ADDENDUM #3
CITY OF PORTSMOUTH, NH
RFP #21-13
REQUEST FOR PORPOSALS
ART FOR PORTSMOUTH MIDDLE SCHOOL
February 5, 2013

This Addendum forms part of the original document marked: Art for Portsmouth Middle School, RFP #21-13

The attached pages include answers to questions submitted by email.

A-215

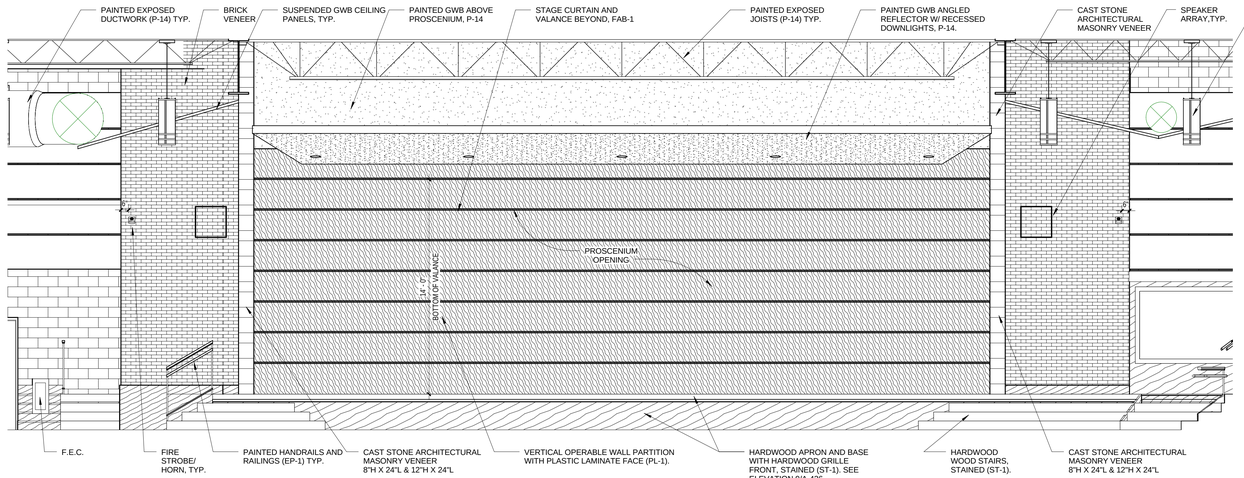
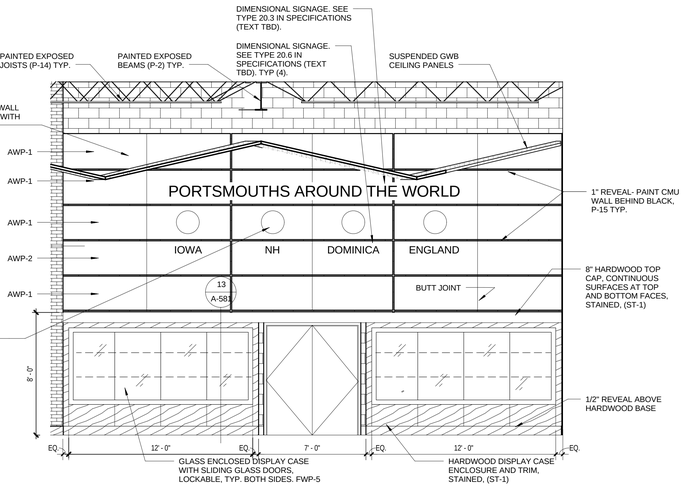
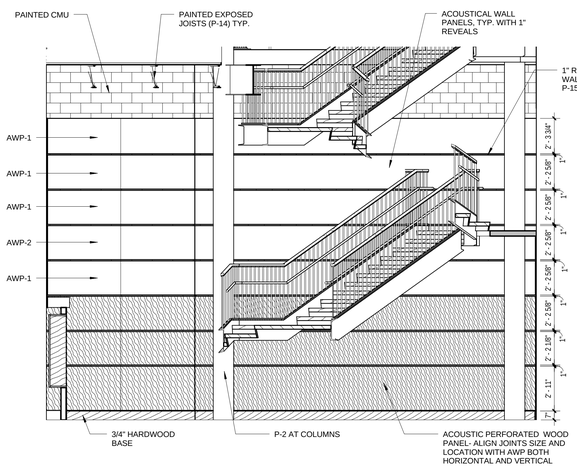
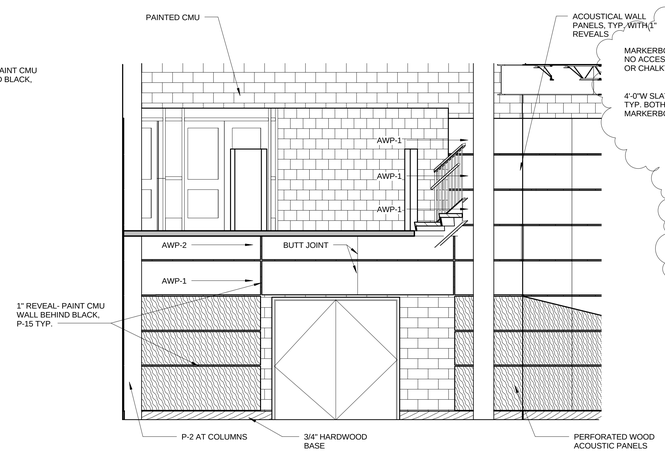
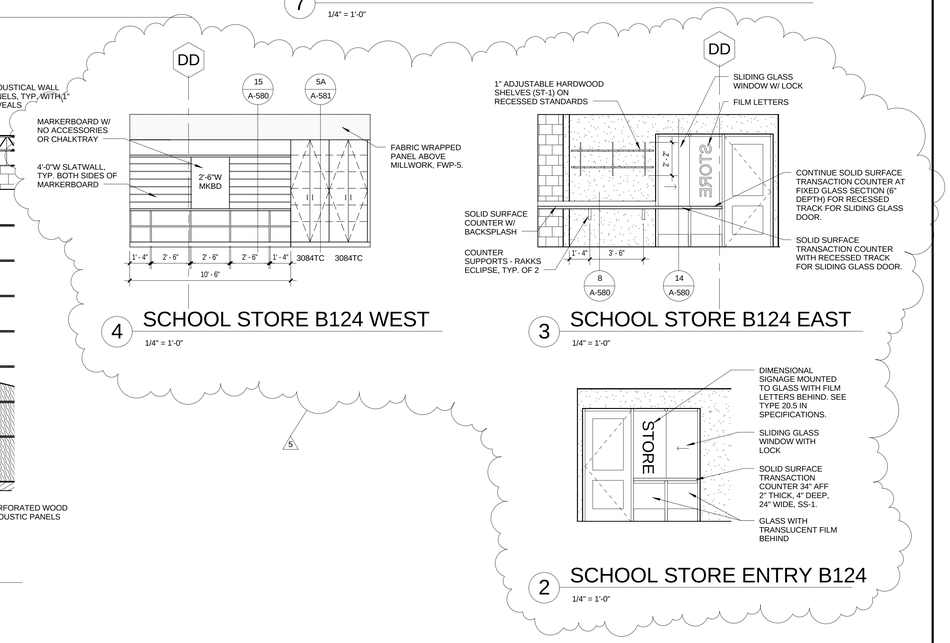
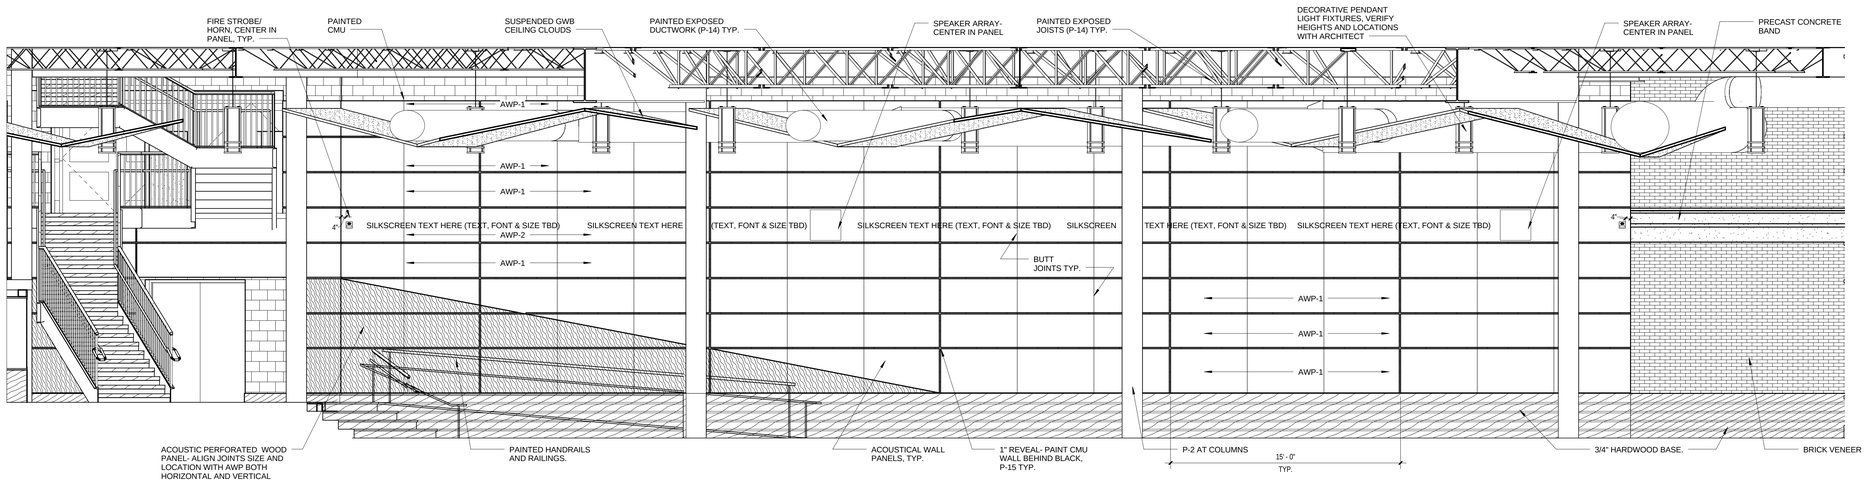
4. **What are the height and volume dimensions of the student commons area, especially in the stairway area and space overlooking the entrance?**

Response: Attached please find a copy of interior elevations of

the Student Commons (Sheet A-215) for reference. Please note, the floor-to-underside of roof structure is approximately 21'-8".

A-216

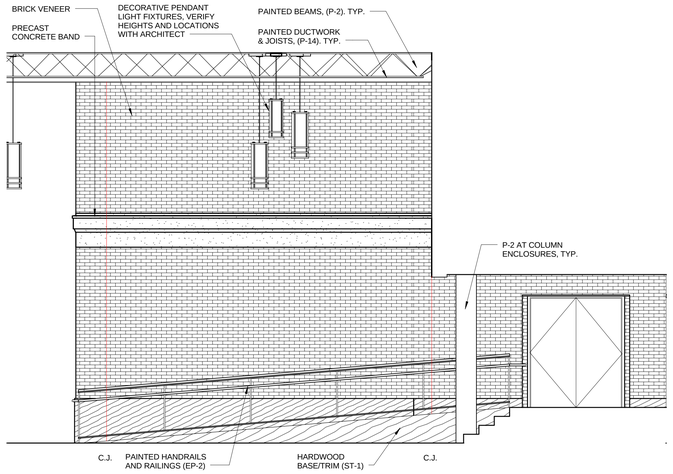
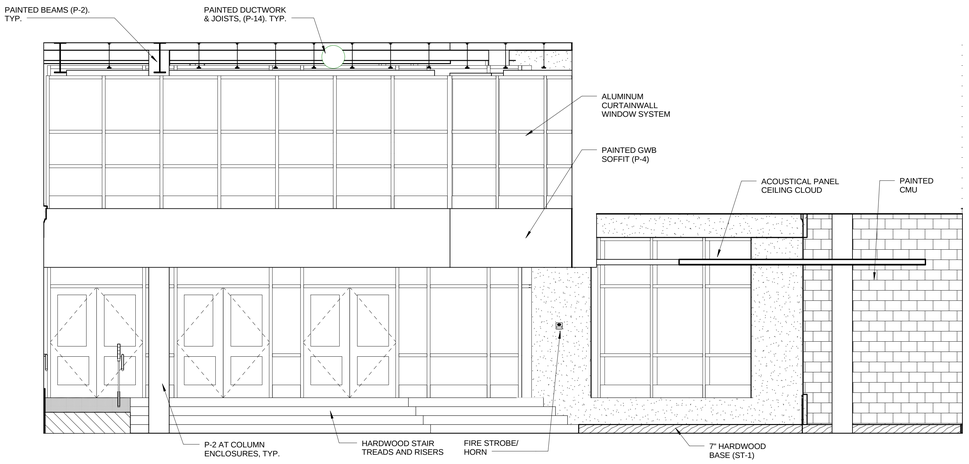
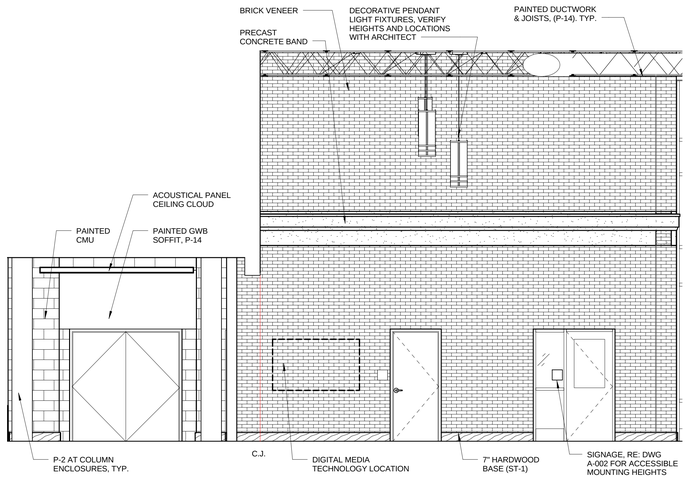
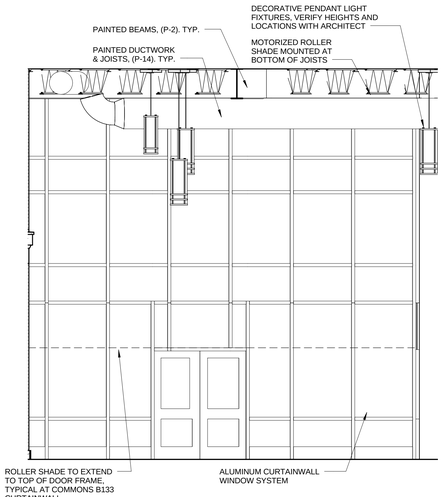
2. **Are drawings of the new (and as yet unbuilt) lobby area available? What dimensions are the space in terms of height and volume? What specific spaces might be available for art in this area?**

Response: Attached please find a copy of interior elevations of the Main Lobby (Sheet A-216) for reference. Please note, the floor-to-underside of roof structure is approximately 23'-0".

A-226

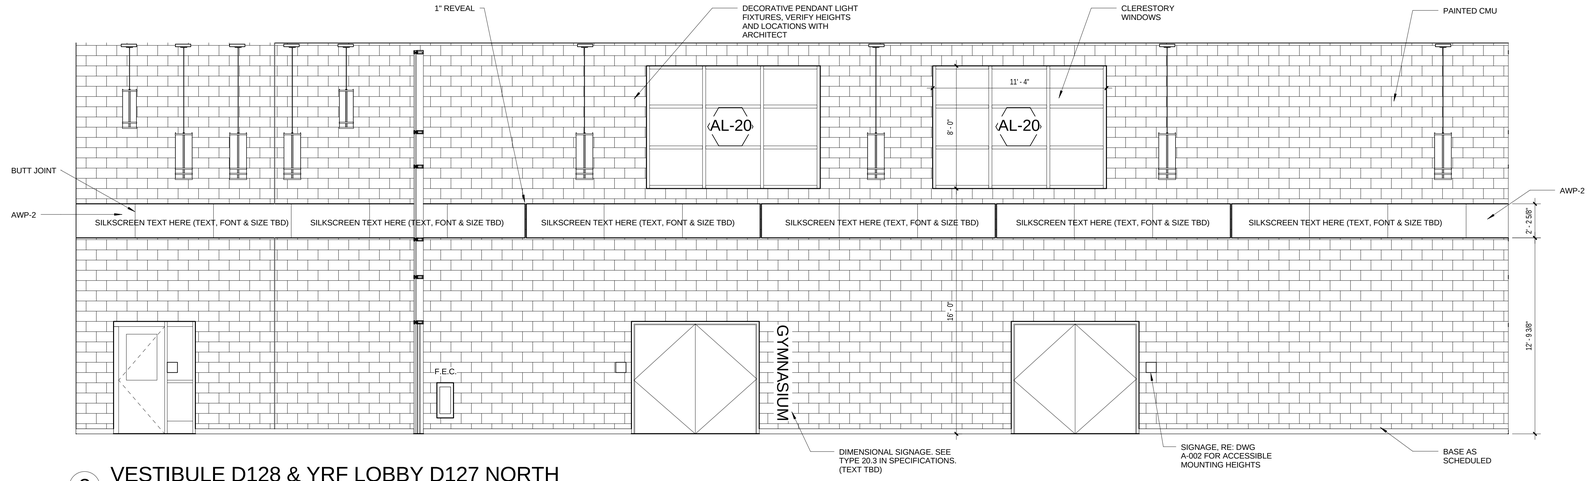
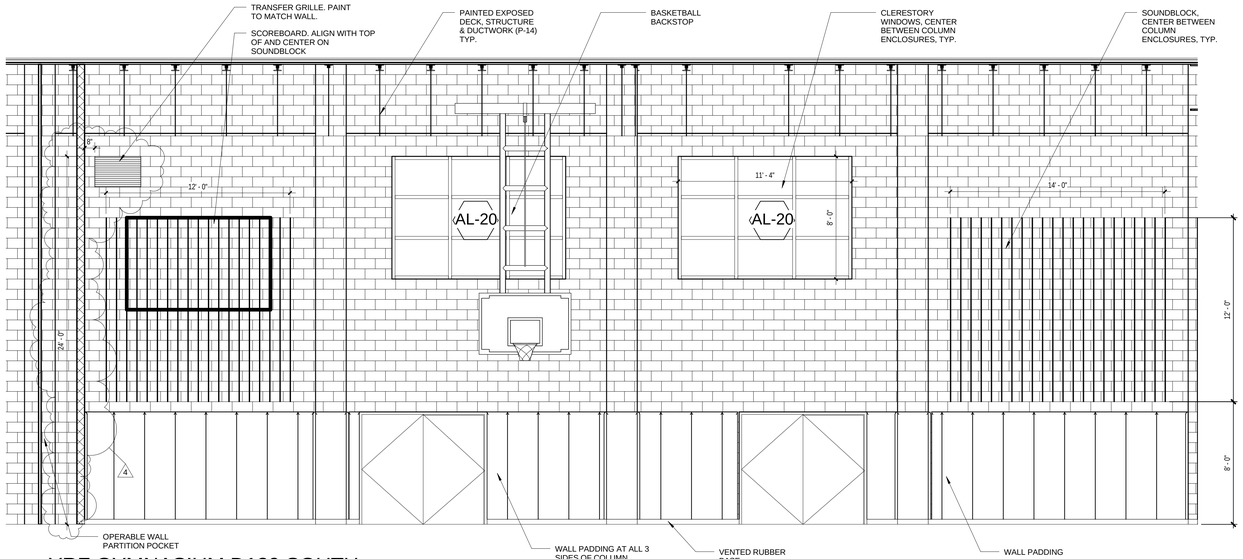
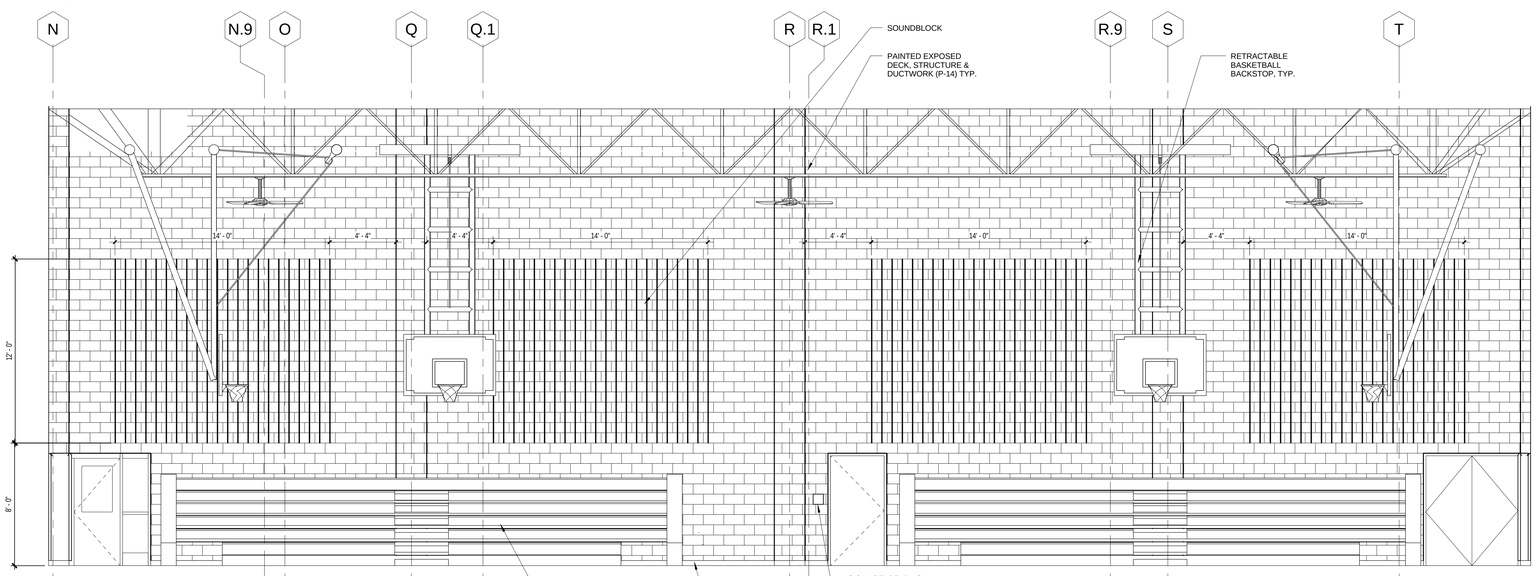
6. **Is there an architectural rendering of the main hallway adjacent to the Connie Bean Community Youth Recreation Center?**

Response: The requested rendering does not exist. Attached please find a copy of interior elevations of the Connie Bean Recreation Center hallway (Sheet A-226) for reference.
